Reference: Engineering Services

Serenity - Lot 55 114 Serendipity Dr. Fuquay-Varina, NC 27526

TE&D Project No.: 2301-020472 A

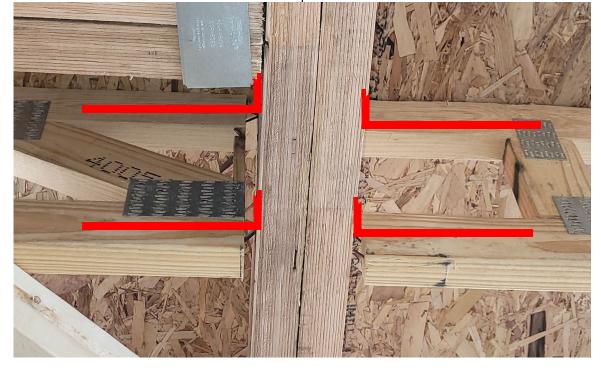
- 1. We observed roof truss "A" was cut at bottom chords 24-25, 23-26, as well as web 23-24. Based on our observations and analysis, the existing truss is not suitable as installed due to the anticipated compression and tension loads associated with the damaged members. The truss is to be repaired and reinforced with the following recommendations:

Furr out LVL $\ensuremath{\text{w}}/$ OSB to fill gap between truss and LVL.

Fully sheathe (1) side of bottom "floor section" of truss

Install Hangers

Install tension ties at top and bottom of each side of cut section. (4) total. Ties may be alternated between truss faces as needed due to space constrictions.

- a. Each side of the LVL beam is to be furred out with 7/16" OSB sheets as needed. Sheets are to be fastened to the beam with (3) rows of 8d nails at 4" o.c. Sheets are to extend to adjacent intersecting members on each side of the damaged truss.

- b. The bottom chord (floor portion) of the truss, from point 16 to 33 is to be fully sheathed with OSB sheets. OSB is to be a minimum 7/16" and is to be fastened to all members with (2) rows of 8d nails at 4" o.c. OSB is only required on (1) face of the truss.

- c. Face mount truss hangers are then to be installed to support the bottom of the truss on both sides of the LVL. Hangers are to be installed on the OSB and fastened per the manufacturer's specifications.

- d. Both sides of the cut truss are then to be reinforced to resist anticipated tension loads. The top and bottom chords of the "floor section" are to be reinforced with a Simpson LTTP2 Tension Tie (or equivalent). Ties are to be fastened with 10d nails or SD screws at all holes. The base is to be fastened to the LVL beam with a minimum 3" long x 1/2" diameter SDWS screw (or equivalent).
